Sydney Grammar School Weigall Fields Sports Complex (SSD-10421) Response to DPIE RFI 19/05/2021

This letter has been prepared to respond to a request for information from Aditi Coomar of DPIE dated 19/05/2021. Part of the RFI relates to flooding:

Figure 1 Probable Maximum Flood

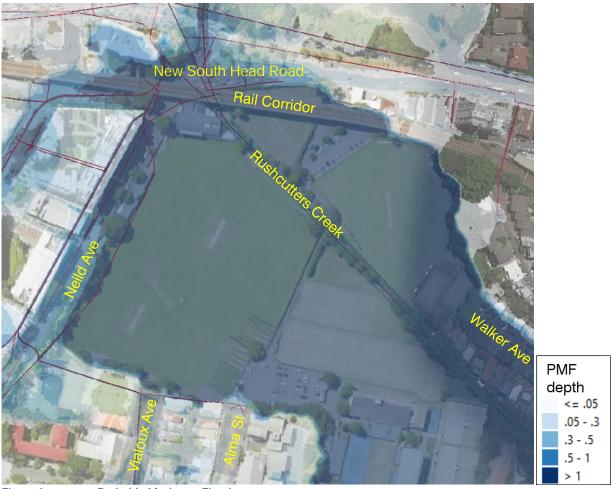
b) Provide greater detail of the potential impact of flooding on the development in case it is proposed to be located adjacent to the railway corridor, including the effect of, or ability to provide, any mitigation.

Any development at the site adjacent to the railway corridor would be very challenging with respect to flooding. Flood levels at the site are presented in Table 1, with a map showing extent and depth of flooding in a PMF in Figure 1.

As per the DCP requirements, the minimum floor level should be no lower than the PMF at 6.10 mAHD. Filling of the floodplain would result in raising flood levels for neighbouring properties which is not acceptable.

A building with an open undercroft may be possible, with a minimum floor level of 6.10 mAHD suspended over the existing ground. The undercroft area cannot be used for car parking or storage, as non-habitable floors must also be above the PMF level. These requirements severely impact any development at the site.

Flood evacuation from a site adjacent the rail corridor would be near impossible, as all access points to the building are flood affected in a 1% AEP flood event. A shelter in place policy could be a valid option for the site but is not recommended due to the depth of flooding in a PMF (3.0m to 3.7m flood depth). The access via Walker Avenue has a flood depth in the order of 2m during a PMF event.
